Model: Cattleya2		Date: 16-May-01	No.: MB023001
Modified Article: ICs on the Video Control Board		Prepared by: H.K.	
From: Technical Service Dept., GTS Division			
Reason for Modification:	<input type="checkbox"/> Parts catalog correction <input type="checkbox"/> To facilitate assembly <input type="checkbox"/> Part standardization	<input checked="" type="checkbox"/> Vendor change <input type="checkbox"/> To improve reliability <input type="checkbox"/> Other	<input type="checkbox"/> To meet standards ()

Model: Cattleya2		Date: 17-May-01	No.: MB023002
Modified Article: Feed Rollers		Prepared by: H.Matusi	
From: Technical Services Dept., GTS Division			
Reason for Modification:	<input type="checkbox"/> Parts catalog correction <input type="checkbox"/> To facilitate assembly <input type="checkbox"/> Part standardization	<input checked="" type="checkbox"/> Vendor change <input type="checkbox"/> To improve reliability <input type="checkbox"/> Other	<input type="checkbox"/> To meet standards ()

28. TRANSFER BELT CLEANING 1 (B023)

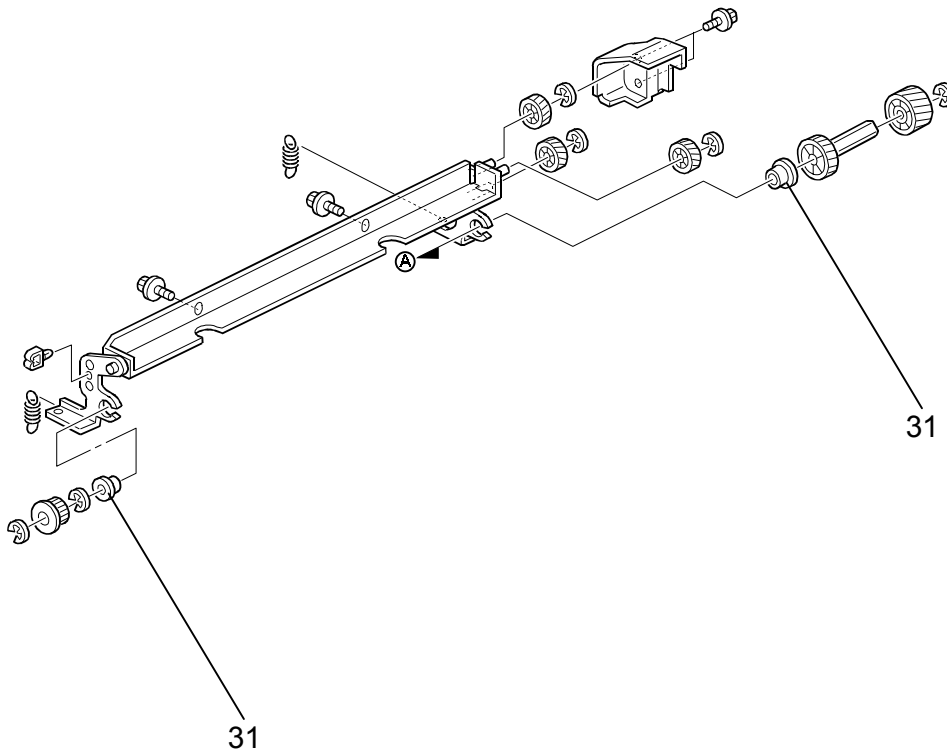
Old part number	New part number	Description	Q'ty	Int	Page	Index	Note
B0236451	B0236452	Cleaning Unit	1-1	X/O	67	*	
54132279		Bushing 8mm	6-4		67	3	
	AA080299	Bushing W-802: 8mm	0-2		67	31

43. DRIVE SECTION 1 (B023)

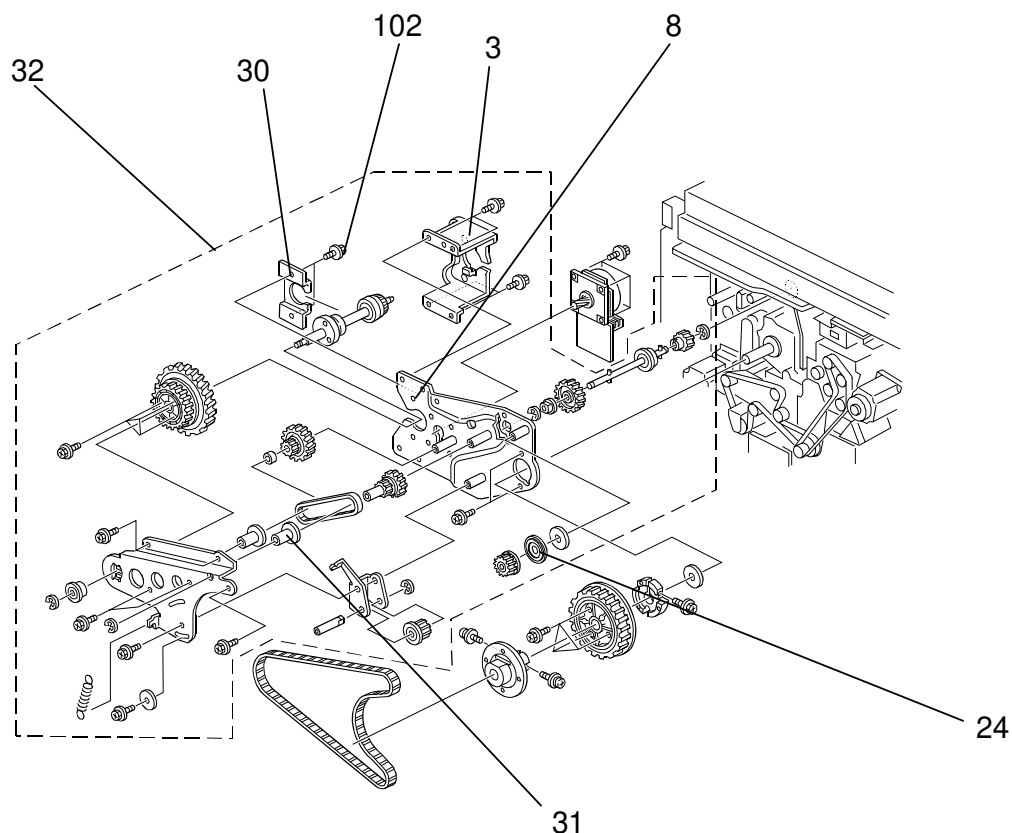
Old part number	New part number	Description	Q'ty	Int	Page	Index	Note
B0234704	B0234714	JOINT ANGLE	1-1	X/O	97	3	
B0234705	B0234716	FRONT SIDE PLATE	1-1	X/O	97	8	
52193633	B0234709	FLANGE PULLEY IDLER	1-1	X/O	97	24	
	B0234719	BEARING BRACKET	0-1	-	97	30	
	B0234708	FLANGE PULLEY	0-1	-	97	31	
	B0234701	DRUM DRIVE ASSY	0-1	-	97	32	
	04514008B	PHILIPS TAPPING SCREW-M4x8	n-n+2	-	97	102
